UNITED STATES PATENT AND TRADEMARK OFFICE

APPLICATION NO.	FILING DATE	FIRST NAMED INVENTOR	ATTORNEY DOCKET NO.	CONFIRMATION NO.
10/080,933	02/22/2002	Jianzhong Zhang	059864.00665	6502

Office Action Summary	Application No. 10/080,933	Applicant(s) ZHANG ET AL.	
	Examiner Jean B. Corrielus	Art Unit 2611

DETAILED ACTION

Zangi's Fig. 3**Fig.2 of current Application**

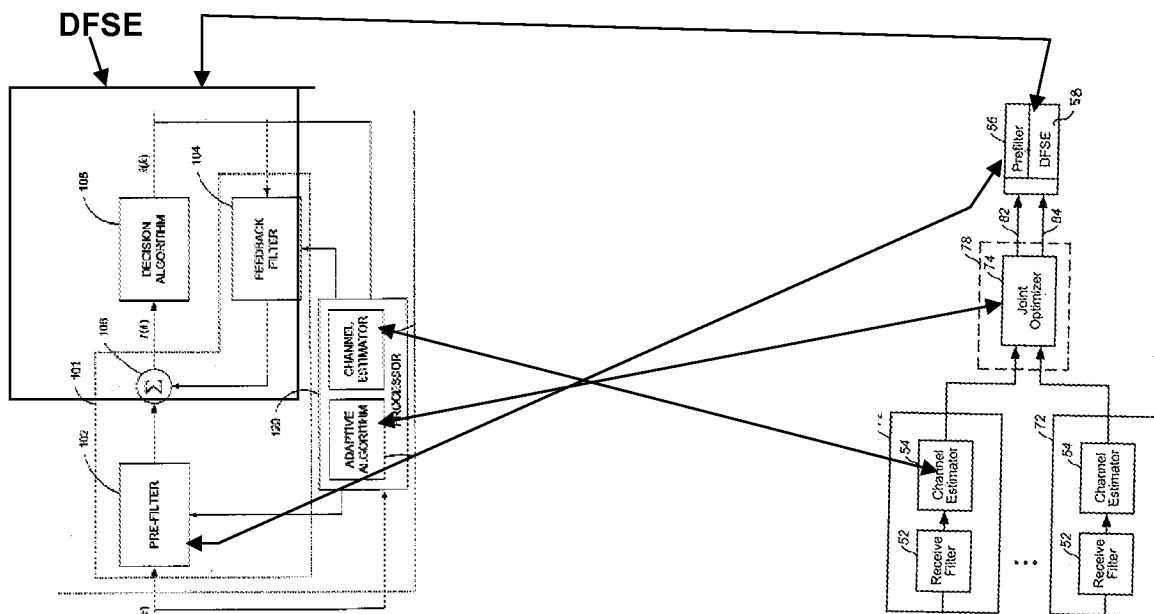
12. Applicant's arguments filed 9/3/09 have been fully considered but they are not persuasive. Applicant argues that the drawings as amended are supported by the specification at least by sections of pages 12-16. However, a review of the entire specification, and specifically the section noted by applicant, fails to support the applicant's position. As noted above under the "drawings" subheading, with respect to fig. 2, the joint optimizer receiving four input signals and providing three output signals is not supported by the original disclosure. In addition, with respect to fig. 3, the structure of the optimizer receiving two input signals and providing three output signals is not supported by the original disclosure. Examiner notes the specification makes it clear that with respect to fig. 2, the optimizer 74 receives estimated values from the channel

estimator (page 12, lines 7-8) and provides optimized parameter values on line 82 and 84 (page 12, line 17) to prefilter and DFSE 56/58 (page 12, lines 20-21) and with respect to fig. 3, the specification at page 13, lines 1-8 makes it clear that the optimizer 74 provides optimized parameter values are provided on lines 82 and 84 to prefilter 56 and feedback filter 92, respectively, values of the data signal filtered by **a prefilter is provided on line 53 to the prefilter 56**. Examiner also notes that fig. 2 and 3 are disclosed as **two distinct embodiments of a portion of the receiving device** shown in fig. 1, see the specification page 8, lines 13-16.

Applicant further submits that **Zangi fails to disclose or suggest each and every element recited in claims 21 and 38. Specifically, Zangi fails to disclose or suggest, at least, "a decision feedback sequence estimator configured to receive the generated optimized values, wherein the decision feedback sequence estimator comprises a summing element, a feedback filter, and a maximum likelihood sequence estimator," as recited in claim 21 (emphasis added), and similarly recited in claim 38.** *However it is noted that such point of arguments have been previously presented by applicant in the response filed on 11/19/08 and rebutted by the examiner in the office action mailed on 12/19/08. Please refer to said office action for the examiner's rebuttal. In addition examiner maintains that at least Fig. 3 of Zangi shows the corresponding claim features of applicant's invention. As shown in the diagram below, each of applicant's claimed feature, shown, for instance in fig. 2, corresponds one to one to each of Zangi's components shown at least in fig. 3. The DFSE circuit of Zangi (see diagram below) , corresponding to applicant's claimed*

limitation "DFSE", includes a summer 106, a feedback filter 104 and a maximum likelihood sequence estimator 108. in addition, the adaptive algorithm 124 of zangi corresponds to signal optimizer, shown in applicant's fig. 2, as block 74. Zangi further teaches a channel estimator 122, shown in applicant's fig. 2 as 54. Zangi teaches a prefilter 102 corresponding to applicant's circuit block 56 depicted in fig. 2. Since Zangi teaches every feature of the claimed invention, i.e., structurally and functionally, as depicted in the above rejection, and further, as shown in the mapping below, zangi anticipates the claimed invention.
